TECHNICAL BULLETIN

Console performance improvements.

KLAR KTEKNIK ENGINEERING CHANGE NOTE

ECN Number
3808

Product
LC301

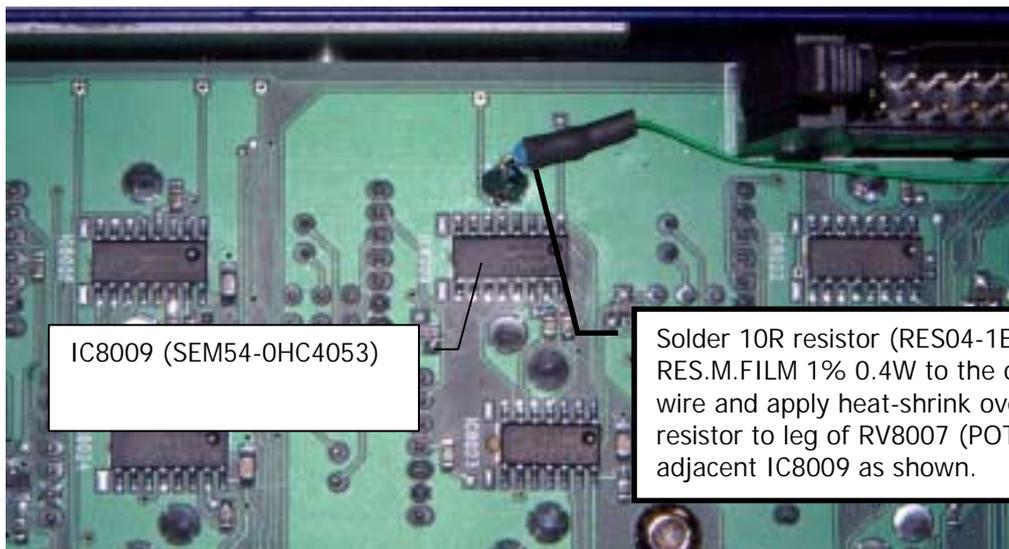
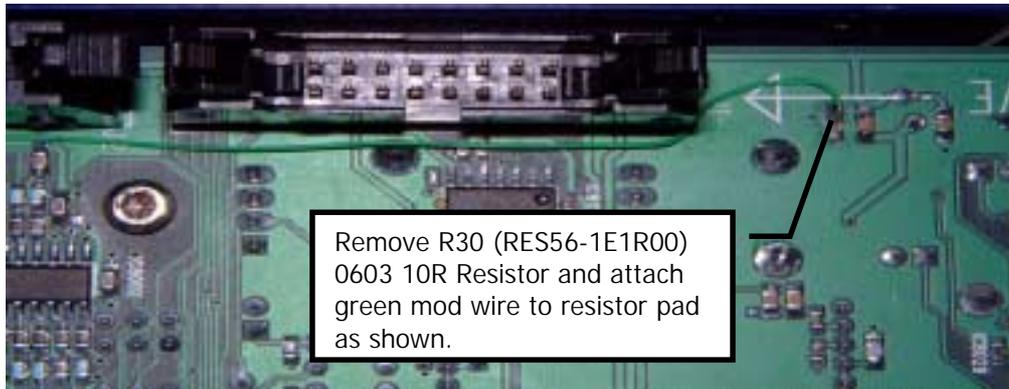
Old	N	
				Quantity	Q	
BOM Changes						
<u>Delete</u>	24 Off	RES56-4E1R00	10K 0603 1% M.FILM RES	REF: R1190,R1191,R1192 R2056,R2057,R2040,R319 R3191,R3192,R4190,R419 R4192,R5190,R5191,R519 R6190,R6191,R6192, R7190,R7191,R7192,R819 R8191,R8192	353	3
<u>Add</u>	24 Off	RES56-3E2R70	2K7 0603 1% M.FILM RES	REF: R1190,R1191,R1192 R2056,R2057,R2040,R319 R3191,R3192,R4190,R419 R4192,R5190,R5191,R519 R6190,R6191, R6192, R7190,R7191,R7192,R819 R8191,R8192	0	2

REASON FOR REQUEST: Cross talk onto master busses

PRODUCTION MODIFICATION NOTICE

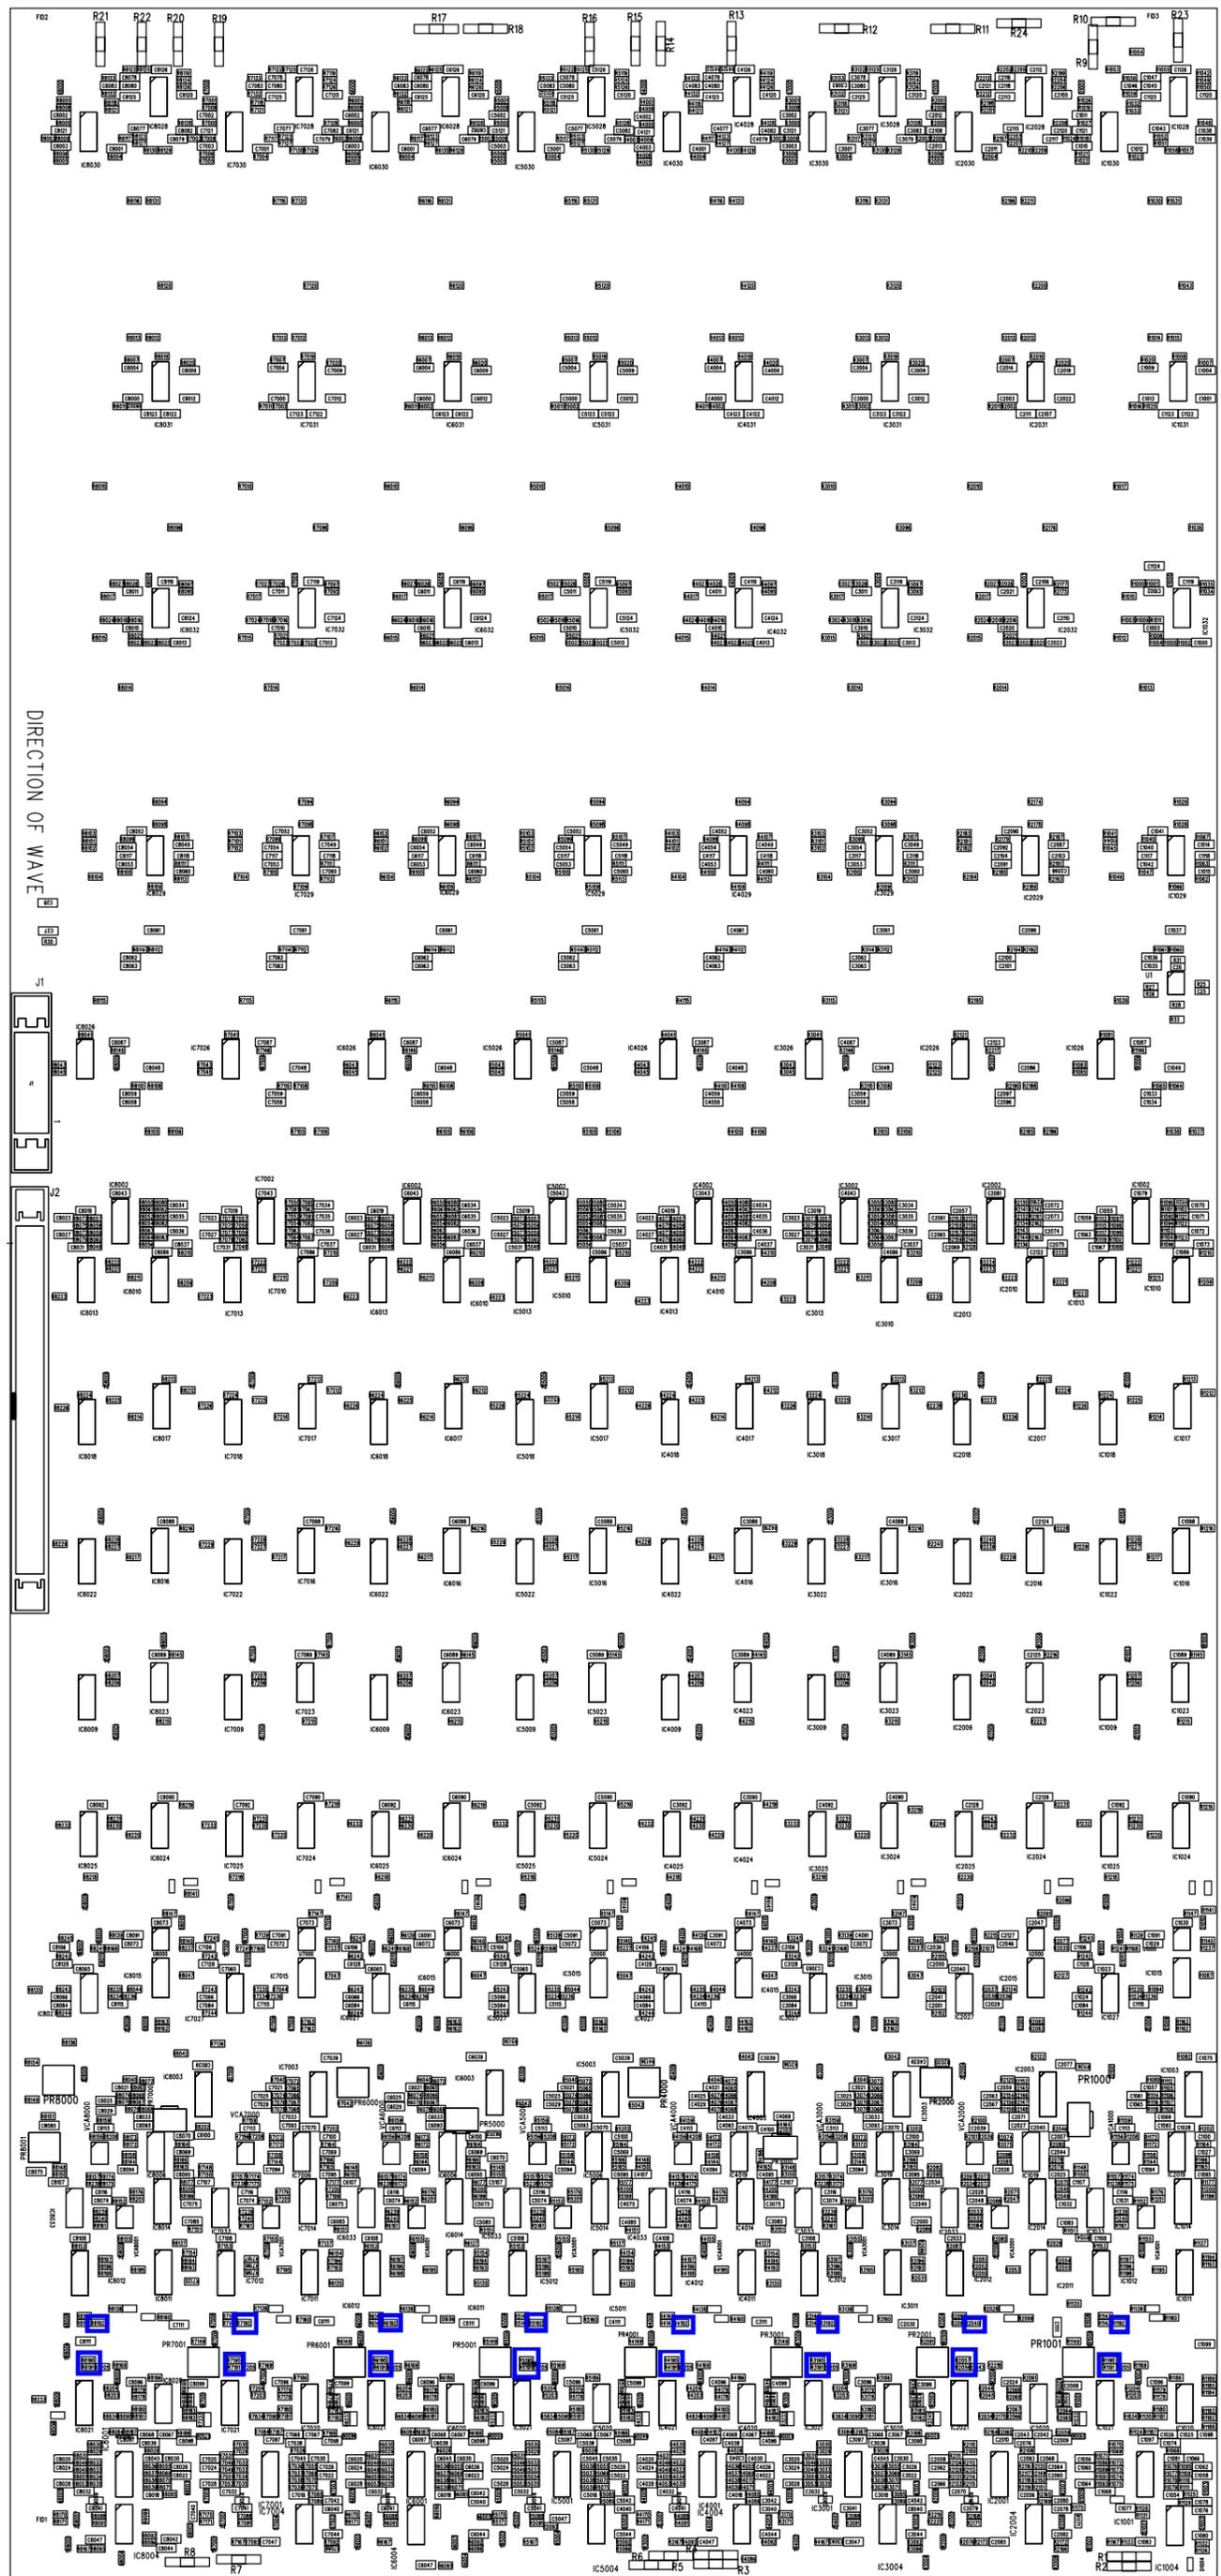
MODIFICATION NO.	150	
PRIORITY	IMMEDIATE IMPLEMENTATION.	
PART NO:	PCX-LC301A-3 & PCX-LC301A-4	
NAME	Legend Main PCB	
RELATED ASSEMBLIES	LC301A-3 & LC301A-4 Legend Input Main PCB Assembly	
CONCESSION	N/A	
RFC/ECN	3823	
CLOSING DATE OF MOD	On release of Issue 5 PCB.	
REQUESTED BY	Alex Cooper	
CHECKED BY		
APPROVED BY		
ISSUE DATE

'Customer complaint regarding noise on the Master Busses.'
